MONTICELLO NUCLEAR GENERATING PLANT E-5979
Responses to Comments
Draft Environmental Statement

RESPONSES TO COMMENTS IN CONNECTION WITH
DRAFT ENVIRONMENTAL STATEMENT FOR THE
MONTICELLO NUCLEAR GENERATING PLANT

Responses to United States
Department of the Interior
and Minnesota Department of
Natural Resources Comments
on the AEC Draft Environmental
Statement.

FIGURE 1

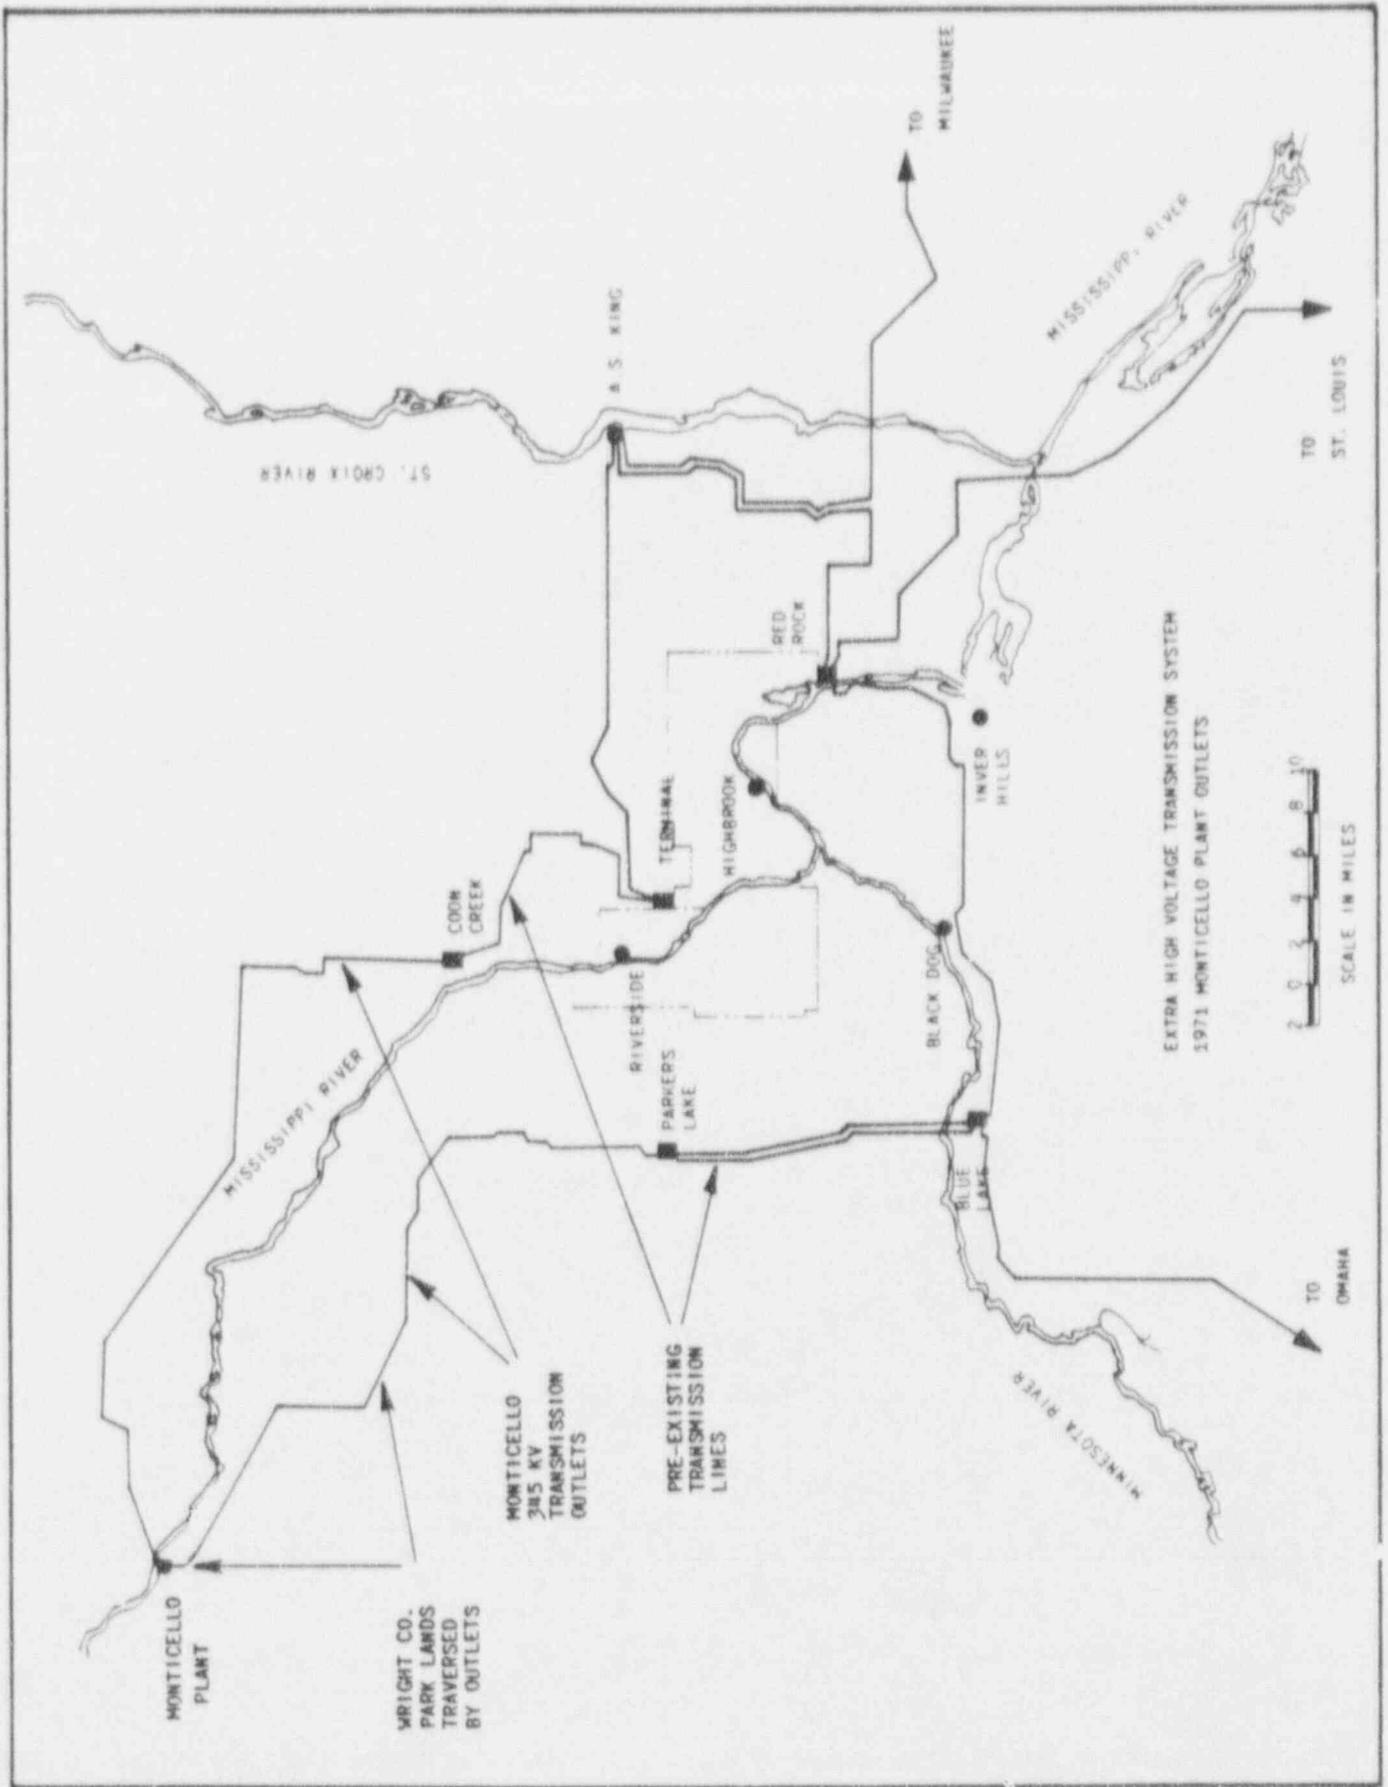
According to page III-1 the transmission line routings attempted to avoid active farm areas and where possible municipalities, county parks, ...In order to assess the environmental impact of the transmission lines, we believe that the statement should address itself to elucidating this statement ...in the form of a discussion with maps and illustrations showing the location of recreational, natural scenic and historic areas traversed by the transmission lines ...If no historic, scenic, county parks or recreational areas are traversed ...it should be so stated.

Routes of transmission lines constructed for the Monticello Nuclear Plant are identified on FIGURE III-2 of the Draft Environmental Statement. FIGURE II-6 of the Applicant's Environmental Report (included here as

Figure 1) has been modified to show two Wright County parks traversed by the Monticello-Parkers Lake 345kV transmission line. These are the only recreational, natural scenic or historic areas traversed by the Monticello-Parkers Lake line. No areas of this type are traversed by the Monticello-Coon Creek 345kV transmission line. The right-of-way through the county park bordering the City of Monticello on the west, forms a strip 1800 feet long and 155 feet wide. There are two steel lattice transmission towers along this right-of-way, each occupying about 900 square feet ground space. Land spaces occupied by tower structures and air spaces occupied by transmission lines are the only portions of the right-of-way to which access is restricted. The other right-of-way through a park is near the village of Hanover, and occupies a one-third acre triangular area, bounded on the east by the Crow River. No transmission towers occupy the right-of-way through the park.
